### Questions & Answers for interpretation of PI-07

For questions related to Option B and B1, see Q & A #1 to 15.

#### Q-1 : Can this facility be approved to operate option B?

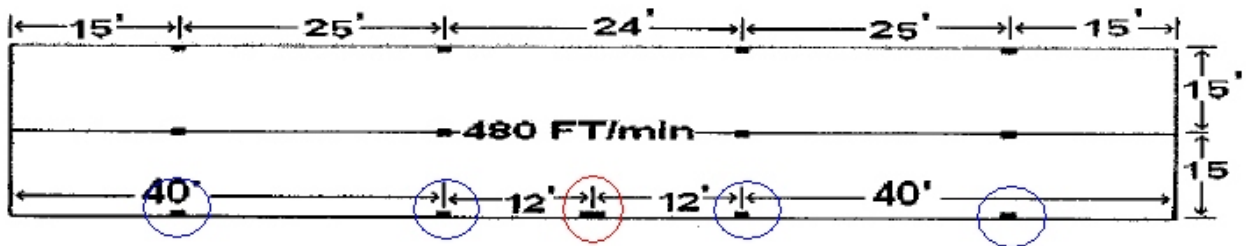
Requirements Option B	This facility	Conform
At least one wet bulb located near the midpoint of the heat chamber	One wet bulb located at the midpoint of the heat chamber	Y
At least one dry bulb located near the midpoint of the heat chamber	There are 4 dry bulbs located on the same side in the kiln. There is no dry bulb at the midpoint but the 4 dry bulbs compensate for the one that is supposed to be at the midpoint.	Y

A-1 : Yes

**Q-2 : Can this facility be approved to operate option B 1**

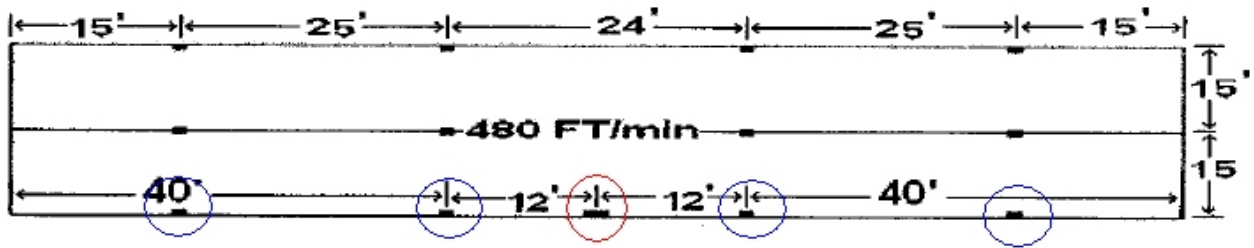
Requirements Option B 1	This facility	Conform
At least one wet bulb located near the midpoint of the heat chamber	One wet bulb located at the midpoint of the heat chamber	Y
At least 3 dry bulbs located on either side of the heat chamber. Sensors must be spaced approximately at equal distance apart perpendicularly to the air flow. One Sensor must be located at each end and must be placed closest to the end (apprx < 5m (16,5 feet))	12 dry bulbs located at different points in the kiln. 2 of them are situated at each end of the heat chamber (15 feet from each door). In this case, there are also 4 dry bulbs on one side of the heat chamber approximately at equal distance apart.	Y

A-2 : Yes

**Q-3 :Can this facility be approved under option B ?**

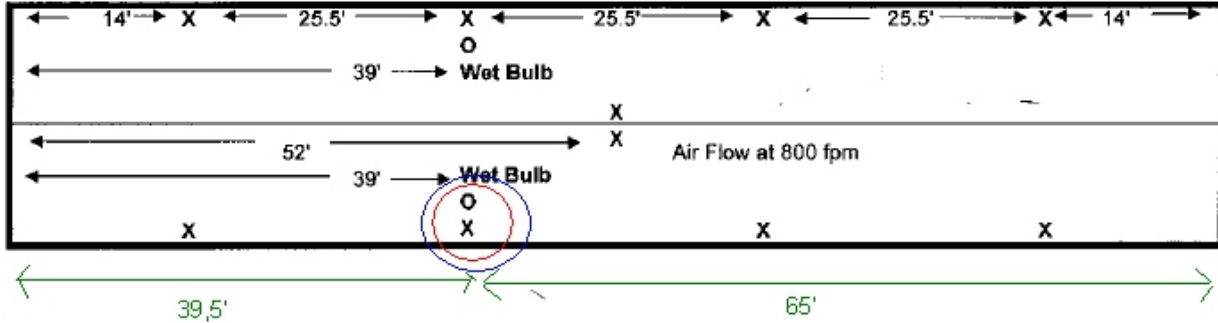
Requirements Option B	This facility	Conform
At least one wet bulb located near the midpoint of the heat chamber	One wet bulb located in the third section of the heat chamber	Y
At least one dry bulb located near the midpoint of the heat chamber	One dry bulb located in the third section of the heat chamber	Y

A-3 : Yes

**Q-4 : Can this facility be approved to operate under option B1 ?**

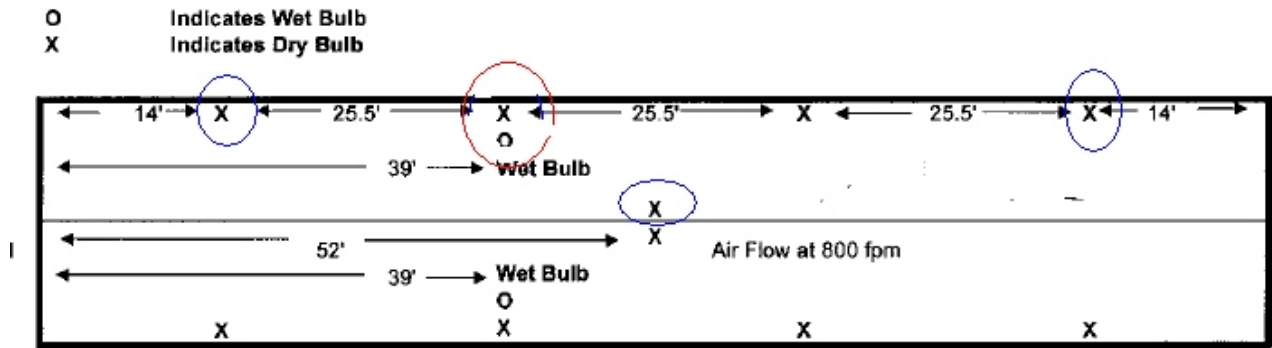
Requirements Option B 1	This facility	Conform
At least one wet bulb located near the midpoint of the heat chamber	One wet bulb located in the third section of the heat chamber	Y
At least 3 dry bulbs located on either side of the heat chamber. Sensors must be spaced approximately at equal distance apart perpendicularly to the air flow. One Sensor must be located at each end and must be placed closest to the end (apprx < 5m (16,5 feet))	Two dry bulbs are situated at each end of the heat chamber (14 feet from each door). One dry bulb is situated in the mid point so we have at least 3 dry bulbs situated at equal distance apart.	Y

A-4 : Yes

**Q-5 : Can this facility be approved to operate under option B ?**

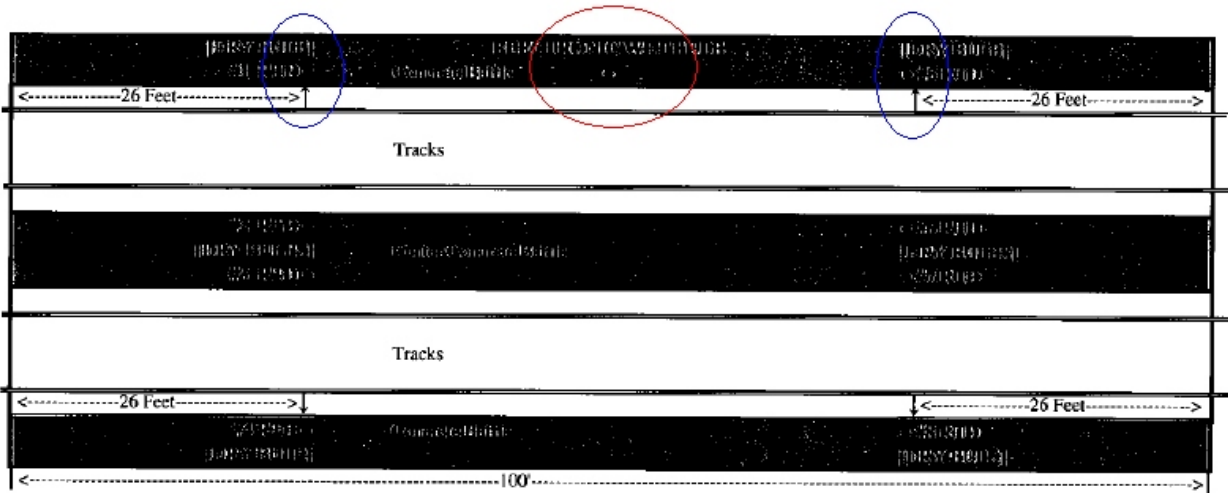
Requirements Option B	This facility	Conform
At least one wet bulb located near the midpoint of the heat chamber	One wet bulb located at the midpoint of the heat chamber	Y
At least one dry bulb located near the midpoint of the heat chamber	There are 2 dry bulbs located on the same side in the kiln. There is no dry bulb at the midpoint but the 2 dry bulbs compensate for the one that is supposed to be at the midpoint.	Y

A-5: Yes

**Q-6: Can this facility be approved to operate under option B?**

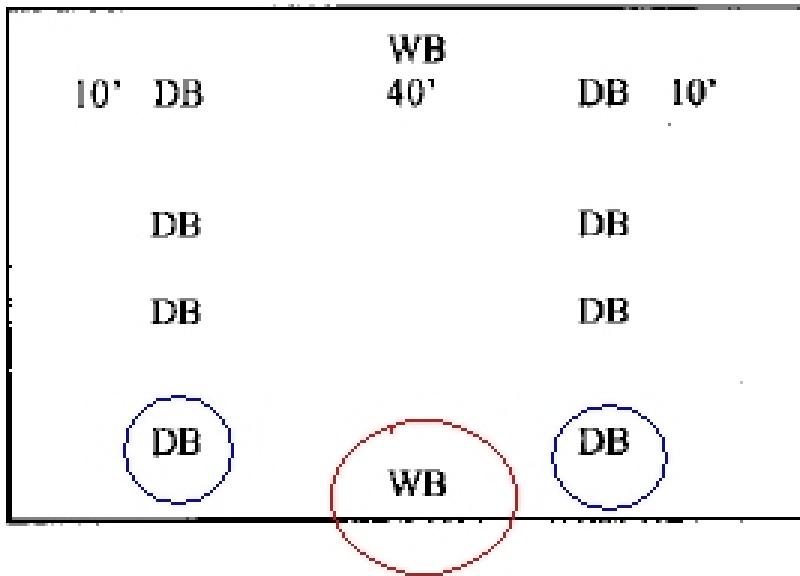
Requirements Option B	This facility	Conform
At least one wet bulb located near the midpoint of the heat chamber	One wet bulb located at the midpoint of the heat chamber	Y
At least one dry bulb located near the midpoint of the heat chamber	There are 2 dry bulbs located on the same side in the kiln. There is no dry bulb at the midpoint but the 2 dry bulbs compensate for the one that is supposed to be at the midpoint.	Y

A- 6: Yes

**Q-7: Can this facility be approved to operate under option B ?**

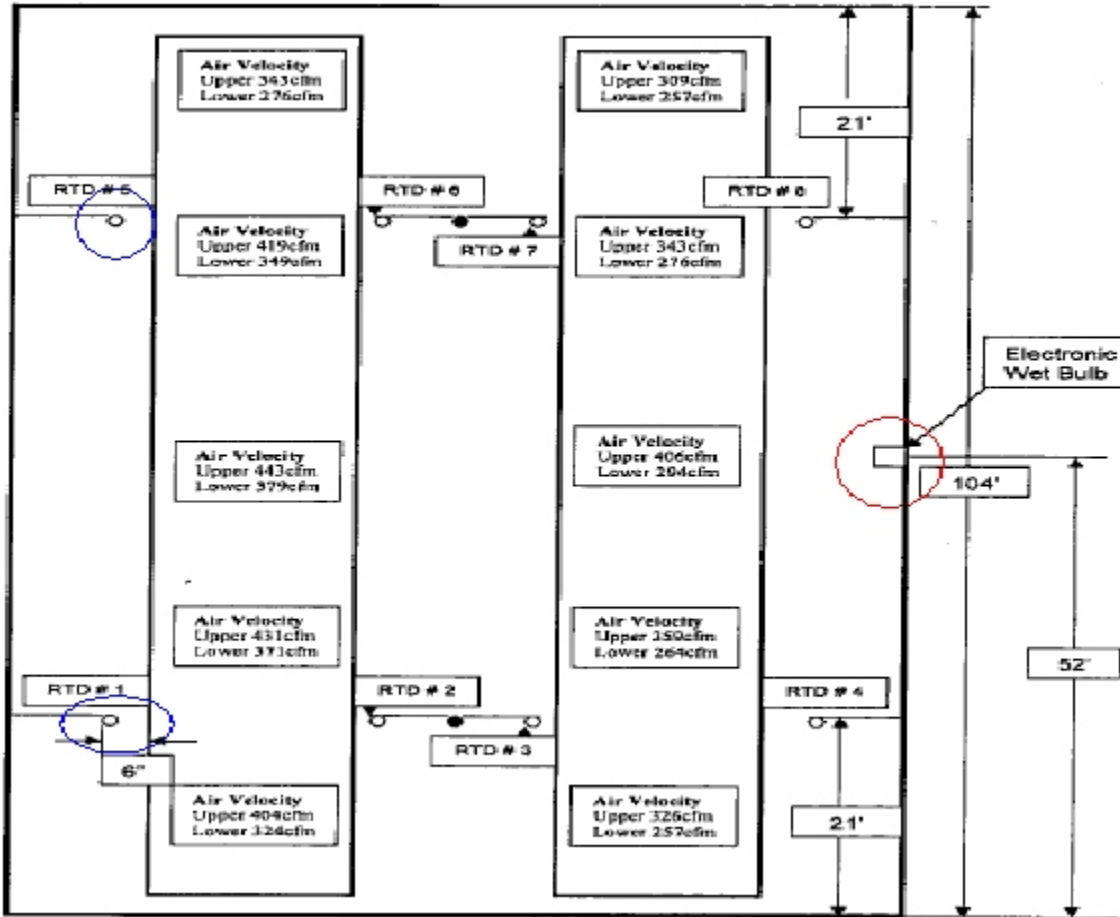
Requirements Option B	This facility	Conform
At least one wet bulb located near the midpoint of the heat chamber	One wet bulb located at the midpoint of the heat chamber	Y
At least one dry bulb located near the midpoint of the heat chamber	There are 2 dry bulbs located on the same side in the kiln. There is no dry bulb at the midpoint but the 2 dry bulbs compensate for the one that is supposed to be at the midpoint.	Y

A- 7: Yes

**Q-8: Can this facility be approved to operate under option B ?**

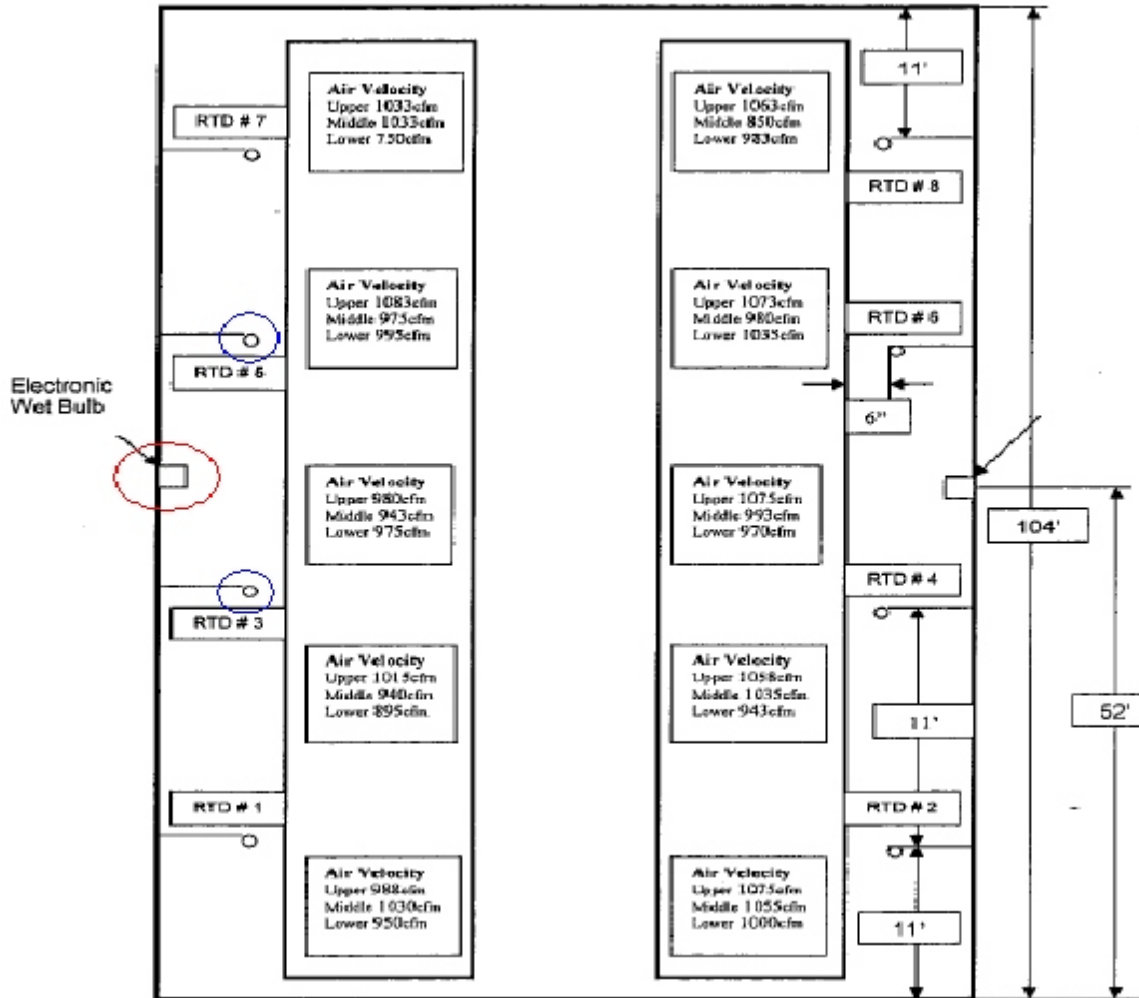
Requirements Option B	This facility	Conform
At least one wet bulb located near the midpoint of the heat chamber	One wet bulb located at the midpoint of the heat chamber	Y
At least one dry bulb located near the midpoint of the heat chamber	There are 2 dry bulbs located on the same side in the kiln. There is no dry bulb at the midpoint but the 2 dry bulbs compensate for the one that is supposed to be at the midpoint.	Y

A-8 : Yes

**Q-11 : Can this facility be approved under option B1 ?**

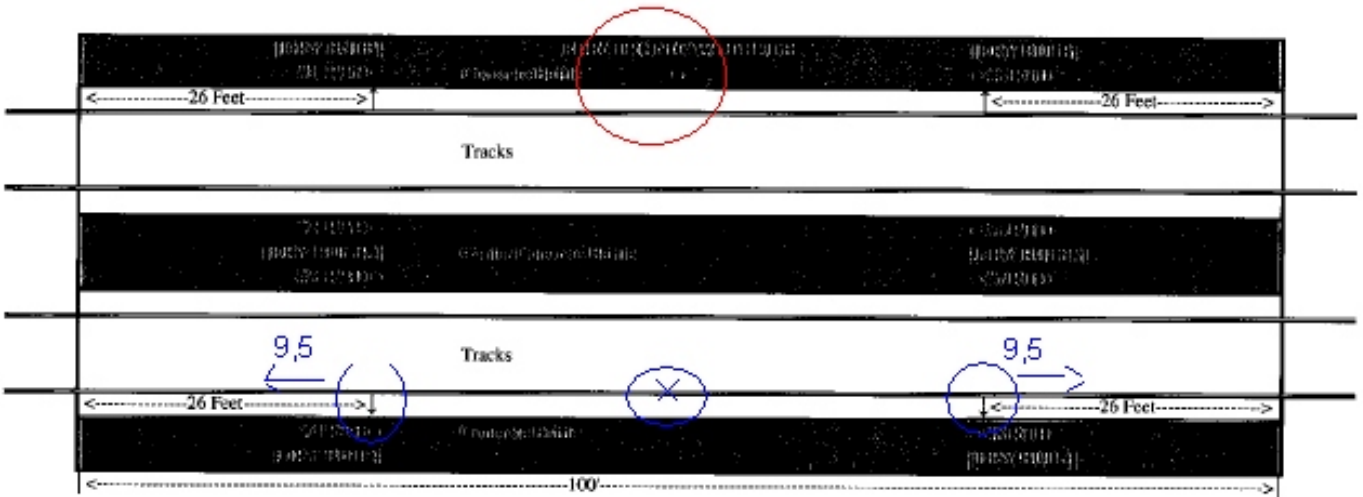
Requirements Option B 1	This facility	Conform
At least one wet bulb located near the midpoint of the heat chamber	One wet bulb located at the midpoint of the heat chamber	Y
At least 3 dry bulbs located on either side of the heat chamber. Sensors must be spaced approximately at equal distance apart perpendicularly to the air flow. One Sensor must be located at each end and must be placed closest to the end (apprx < 5m (16,5 feet))	The two dry bulbs situated near the doors have to be moved. They need to be placed at a maximum distance of 16,5' from the doors. A dry bulb has to be added at the midpoint of the kiln to have 3 dry bulbs at equal distance apart.	N

A-11 : No

**Q-13 : Can this facility be approved to operate under option B1?**

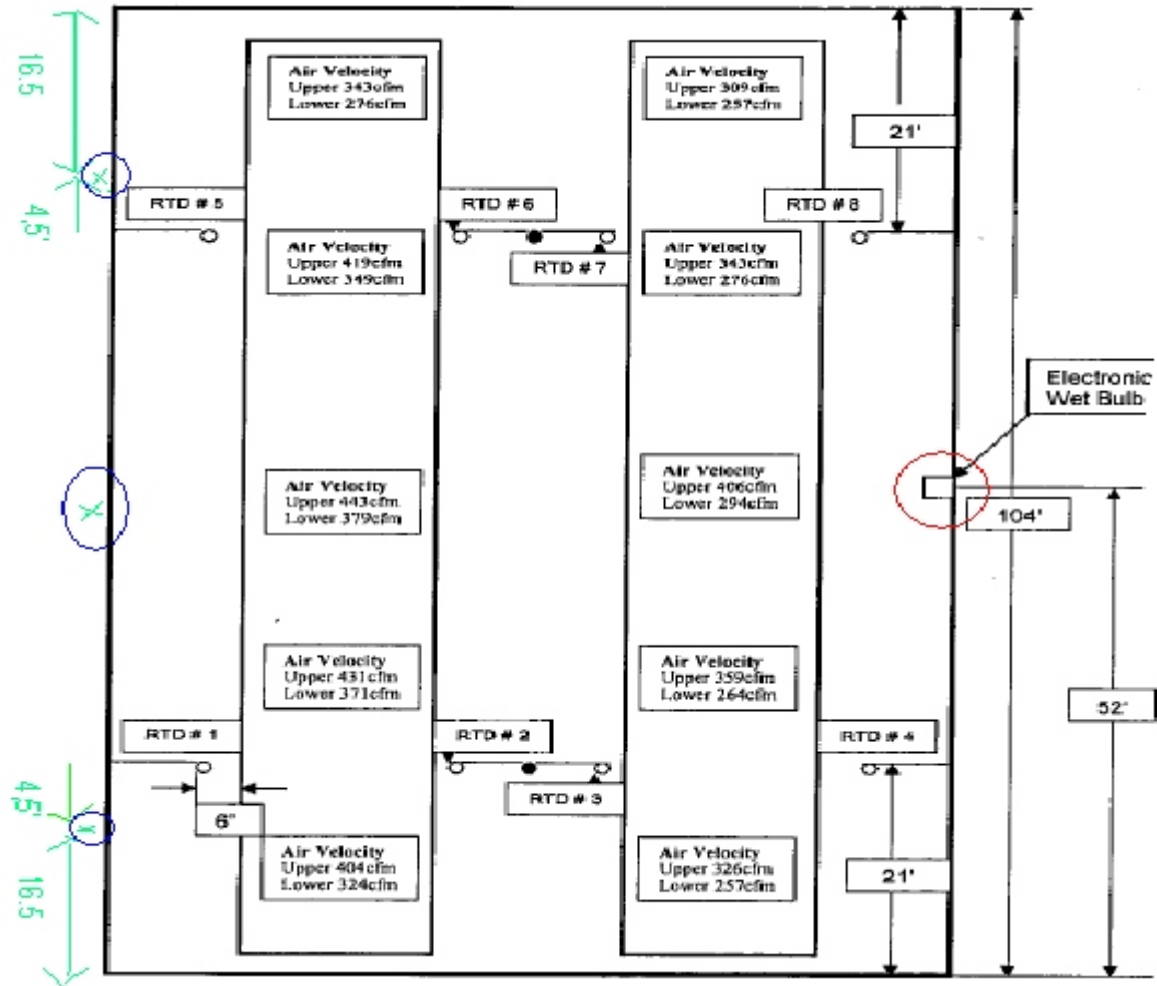
Requirements Option B 1	This facility	Conform
At least one wet bulb located near the midpoint of the heat chamber	One wet bulb located at the midpoint of the heat chamber	Y
At least 3 dry bulbs located on either side of the heat chamber. Sensors must be spaced approximately at equal distance apart perpendicularly to the air flow. One Sensor must be located at each end and must be placed closest to the end (apprx < 5m (16,5 feet))	The two dry bulbs situated near the doors have to be moved. They need to be placed at a maximum distance of 16,5' from the doors. A dry bulb has to be added at the midpoint of the kiln to have 3 dry bulbs at equal distance apart.	N

A-13 : No

**Q-14: Can this facility be approved to operate under option A ?**

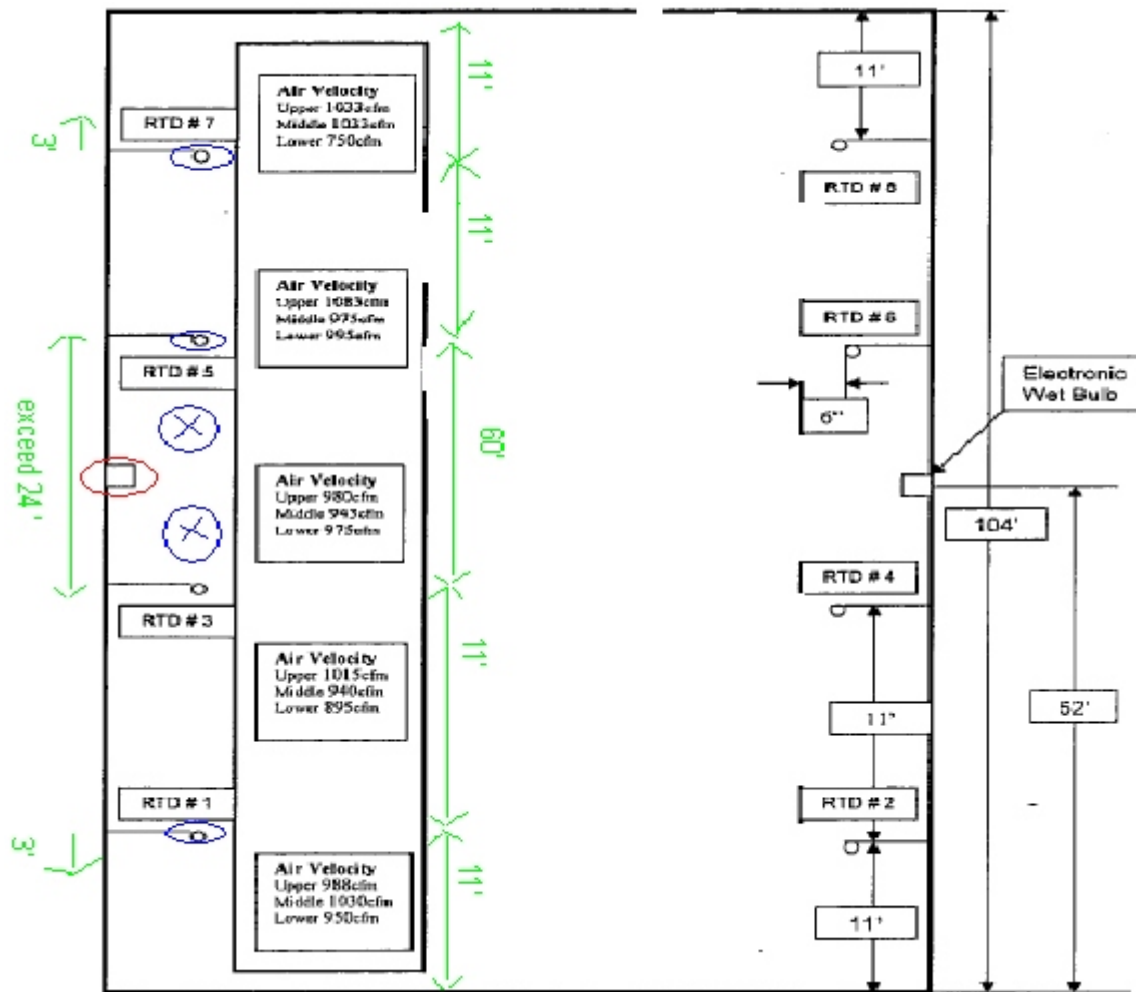
Requirements Option A	This facility	Conform
At least one wet bulb located near the midpoint of the heat chamber	One wet bulb located at the midpoint of the heat chamber	Y
Dry bulb must be spaced not more than 24 feet apart with one located no more than 8 feet from each end of the treatment chamber. The number of dry bulbs will depend on the length of the individual kiln.	The dry bulb near the end of the heat treatment chamber has to be moved (3 ft) to respect the requirement (8ft from each end). 2 dry bulbs have to be added to meet the requirement of no more than 24 ft apart.	N

A- 14: No

**Q-15: Can this facility be approved to operate under option B1 ?**

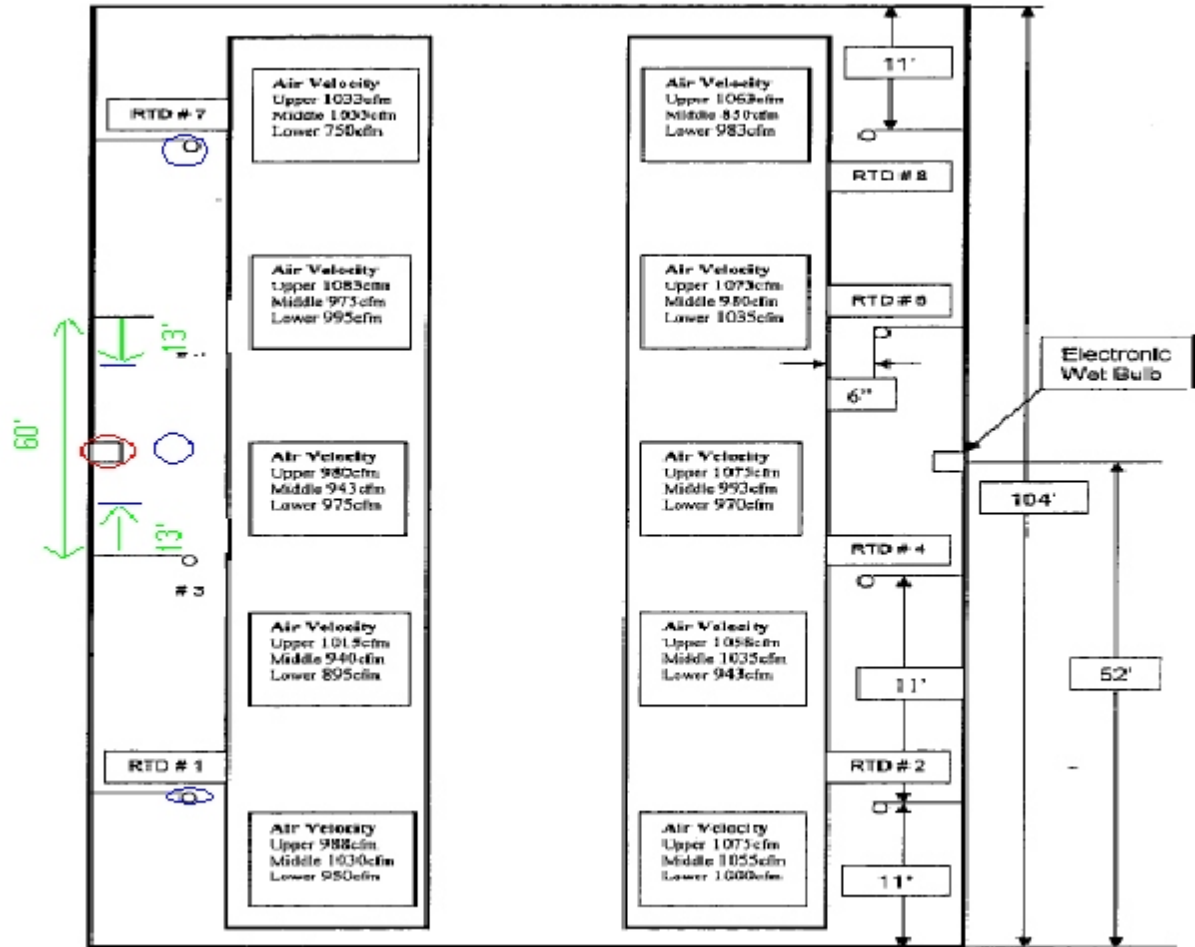
Requirements Option B 1	This facility	Conform
At least one wet bulb located near the midpoint of the heat chamber	One wet bulb located at the midpoint of the heat chamber	Y
At least 3 dry bulbs located on either side of the heat chamber. Sensors must be spaced approximately at equal distance apart perpendicularly to the air flow. One Sensor must be located at each end and must be placed closest to the end (apprx < 5m (16,5 feet))	The two dry bulbs situated near the doors meet the requirement. In order to meet the rule of equal distance between sensors, a dry bulb has to be located at the midpoint and there is no dry bulb at this place. One of the dry bulbs (#3,4,5 or 6) has to be moved in the central part (1/3) to meet the requirement .

A-15 : No
